Prairie Island Nuclear Generating Plant Units 1 and 2  
Dockets 50-282 and 50-306  
License Nos. DPR-42 and DPR-60

Supplement to License Amendment Request (LAR) to Revise the Spent Fuel Pool  
Criticality Analyses and Technical Specifications (TS) 3.7.17, "Spent Fuel Pool Storage"  
and 4.3, "Fuel Storage" (TAC Nos. MC5811 and MC5812)

### **PRAIRIE ISLAND NUCLEAR GENERATING PLANT Response to Request for Additional Information**

**Figure 4.3.1-1**

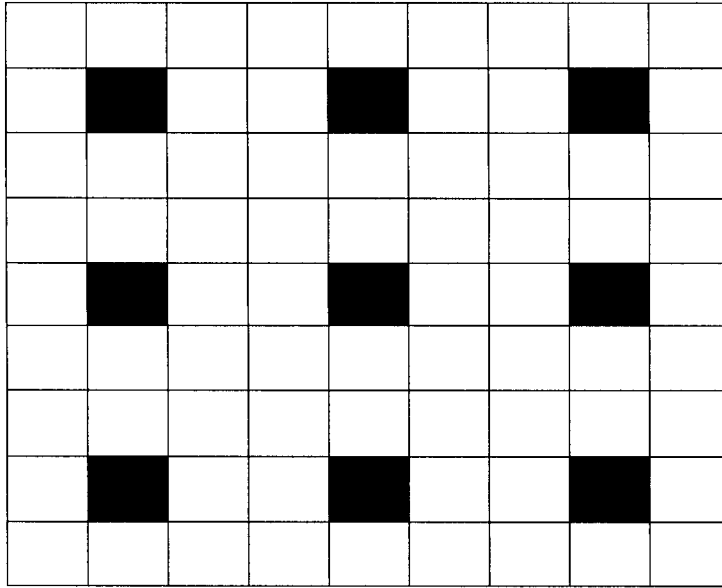
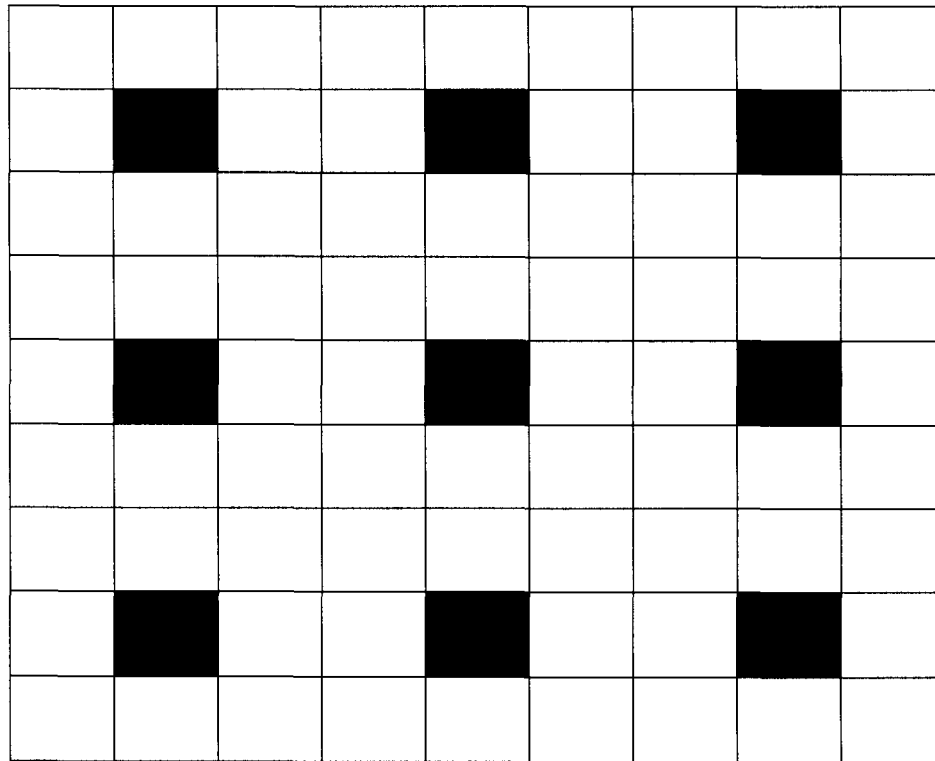
**NMC's proposed TS Figure 4.3.1-1 allows the storage of fresh fuel assemblies in the spent fuel pool with or without gadolinium based on ensuring that adjacent spent fuel assemblies satisfy minimum burnup requirements. However, the licensee did not propose TS limits that will require a minimum gadolinium loading, in accordance with assumptions used in the criticality analyses, in the fresh fuel prior to placing it in the designated storage locations. Therefore, the staff requests that the licensee provide additional information demonstrating that sufficient controls will be put in place to ensure fresh fuel assemblies loaded in the spent fuel storage racks will be appropriately controlled based on the amount of gadolinium.**

The legend for "Fresh Fuel" on proposed TS Figure 4.3.1-1 is revised to include minimum gadolinia (GAD) requirements. The revised figure is provided in Enclosures 2 and 3 of this supplement. With this change, the minimum required gadolinia loading in the fresh fuel is specified and will be controlled by NMC procedures which reference this Figure.

**Assemblies with GAD shall have a minimum of 4 fuel rods with a minimum concentration of 4.0 w/o  $\text{Gd}_2\text{O}_3$**
